SITE PLAN & ARCHITECTURAL COMMISSION AGENDA MARCH 17, 2017

IN THE MATTER OF SITE PLAN AND ARCHITECTURAL COMMISSION)
FILE AC-16-153 APPLICATION FOR PROJECT REVIEW SUBMITTED) ORDER
BY PEOPLE'S BANK OF COMMERCE)

Consideration of plans for an approximately 20,000 square foot, three-story bank and office building on a one acre lot within the Regional Commercial zoning district and the Freeway Overlay District (C-R/F). Subject site is located at the southeast corner of Biddle Road and Progress Drive (Map lot 371W19BB 1504).

Revised Date: 2/6/2017
File Number: AC-16-153
Reference: PA-15-102

Site Plan (Exhibit D)

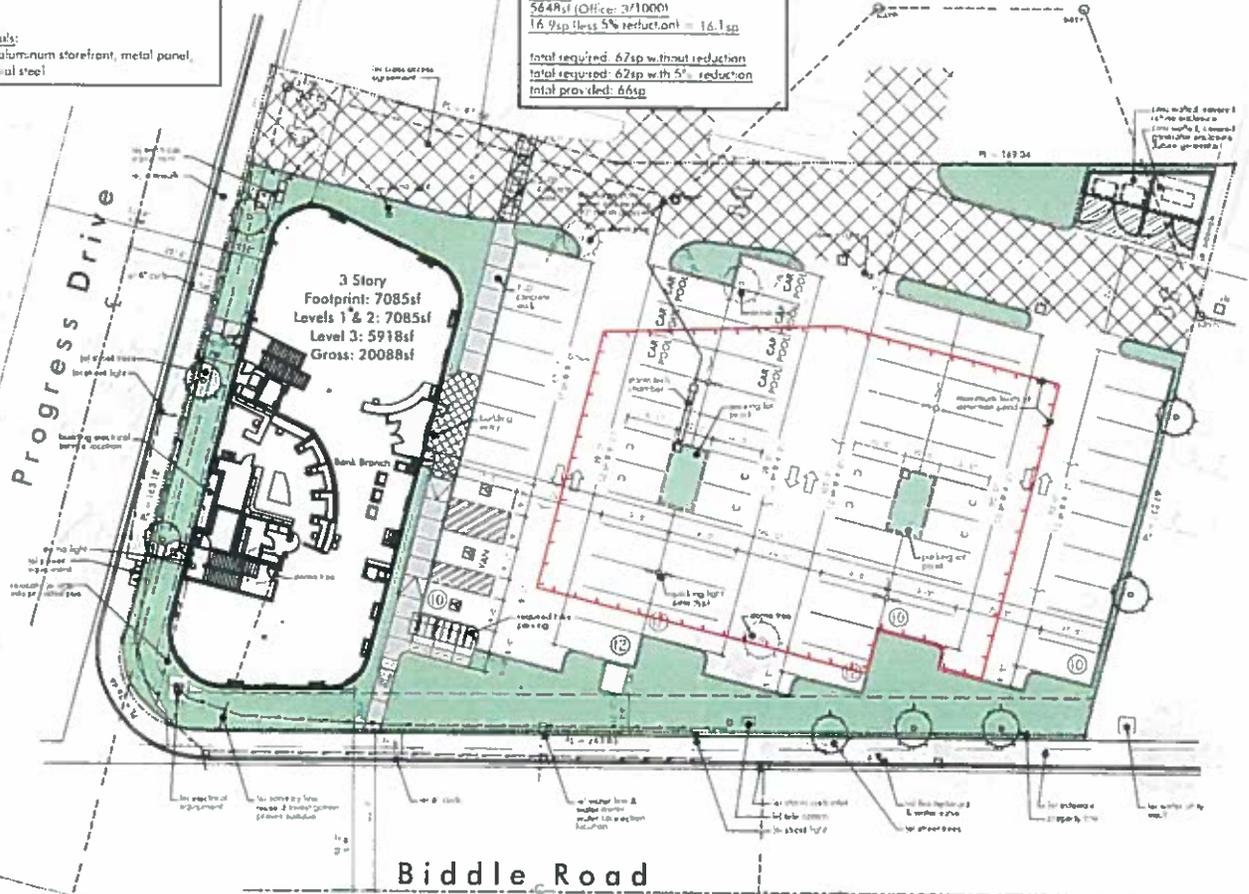
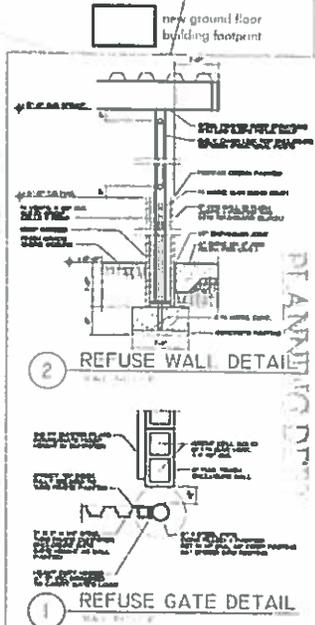
The site plan shows that there are four bike racks on the south side of the building close to the entrance. The site plan does not show the bicycle parking dimensions, lighting, aisle widths, signage or the type of bike rack. A condition has been included requiring the applicant to comply with the bicycle parking requirements in Section 10.750.

The Site Plan (Exhibit D) includes a detail of the trash enclosure. The applicant is proposing a CMU block wall to be covered by a metal roof. Next to the trash enclosure, the applicant is proposing a similar structure to conceal generators. The subject fixtures will fully screen these facilities. These enclosures are sited on the east side of the site where they will not impede vehicles accessing the site from the private drive or cross access ways.

1. Provide a revised site plan showing bicycle parking facilities in compliance with Section 10.750
2. Comply with all requirements of the Medford Public Works Department (Exhibit I), except there is no requirement for additional right-of-way dedication along Progress Drive.
3. Comply with all requirements of the Medford Water Commission (Exhibit J).
4. Comply with all requirements of the Medford Fire Department (Exhibit K).
5. Comply with all requirements of the Medford Building Department (Exhibit L).
6. Comply with the email from Avista (Exhibit N).
